AUGUST 2022 MINOR NON MATERIAL AMENDMENTS TO MCC PLANNING PERMISSION (REF. 132391/FH/2021)

Scheme
Loft Conversion Works
466 Parrs Wood Road
Didsbury
Manchester M20 5QQ
Client

Mr & Mrs Tennant
Title
Proposed Floor & Roof
Plans

Scale 1:50 Date 2.12.21 Drawn MM
Job No P221 Dwg No 15 Rev B

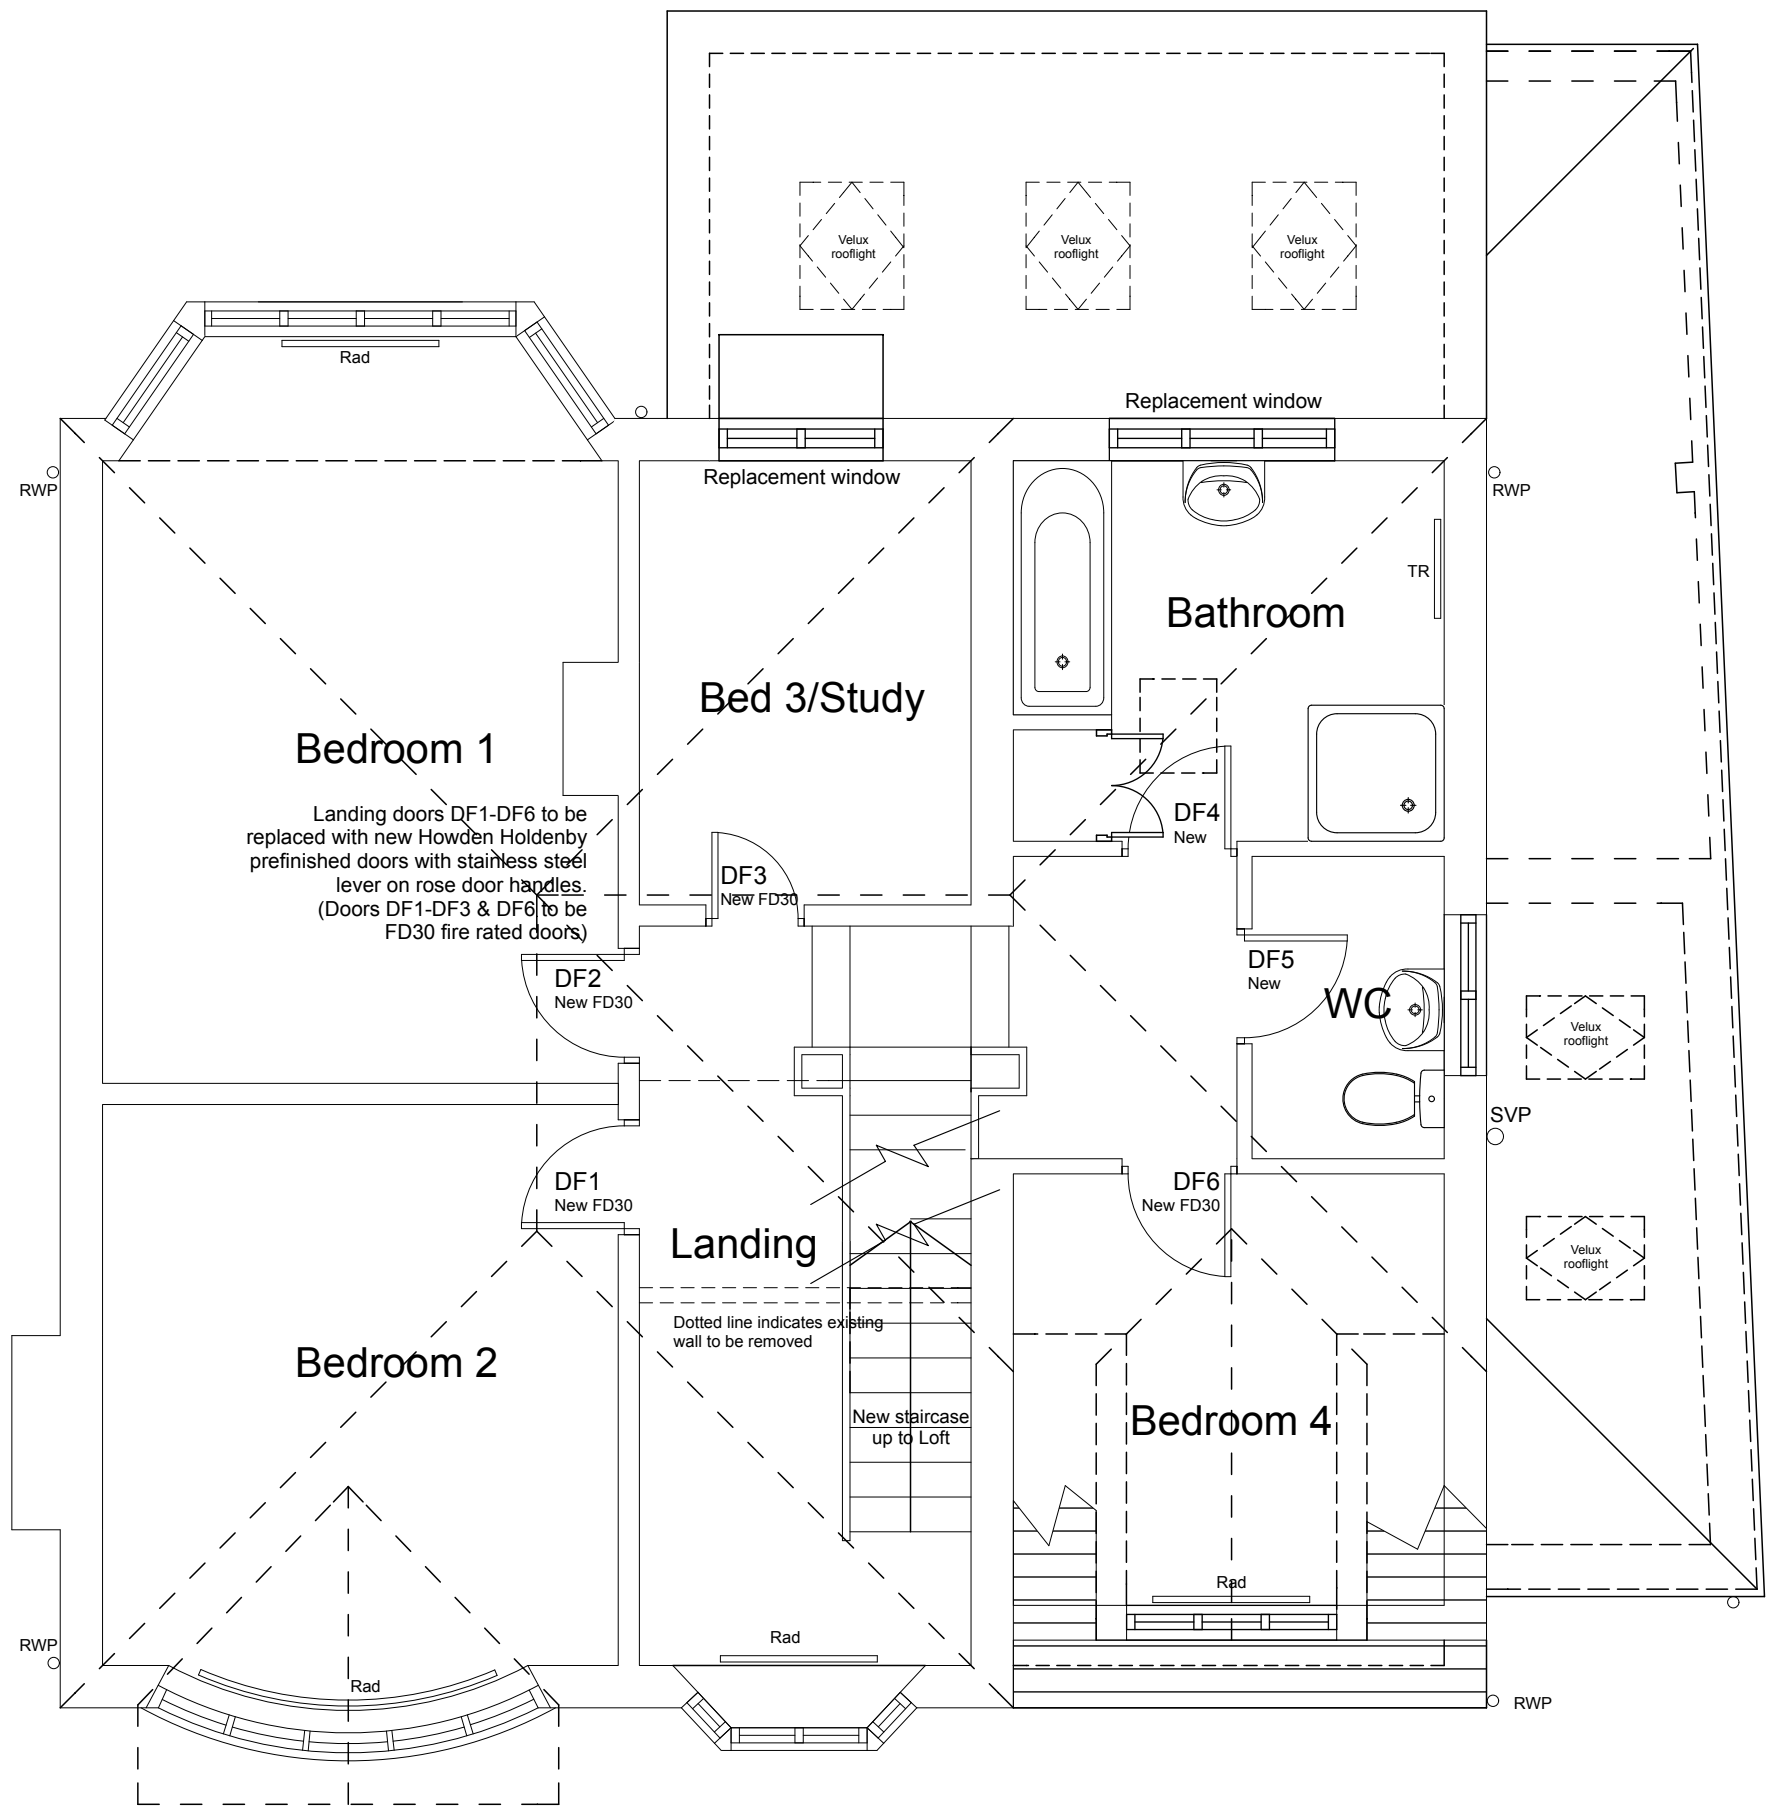
- MINOR ELEVATIONAL NON MATERIAL AMENDMENTS (AUGUST 2022)**
1. SOLAR PANELS OMITTED TO FRONT ELEVATION ROOF
 2. 2NO. VELUX WINDOWS OMITTED TO FRONT ELEVATION ROOF
 3. SLIDING FOLDING DOORS PROVIDED TO SECOND FLOOR REAR ELEVATION IN LIEU OF GLAZED SCREEN/DOOR
 4. CEDRAL CLADDING ON DORMER LOFT REAR ELEVATION AMENDED FROM DARK OAK TO CREAM WHITE (C07) COLOUR
 5. EXISTING CHIMNEY BUILT UP IN BLUE ENGINEERING BRICKWORK 0.75m ABOVE NEW DORMER LOFT ROOF

B. NMA Inner gable cladding changed back to original facing brickwork to match existing 19.8.22
A. NMA Planning Amendments + Internal Notes 19.7.22
REVISIONS
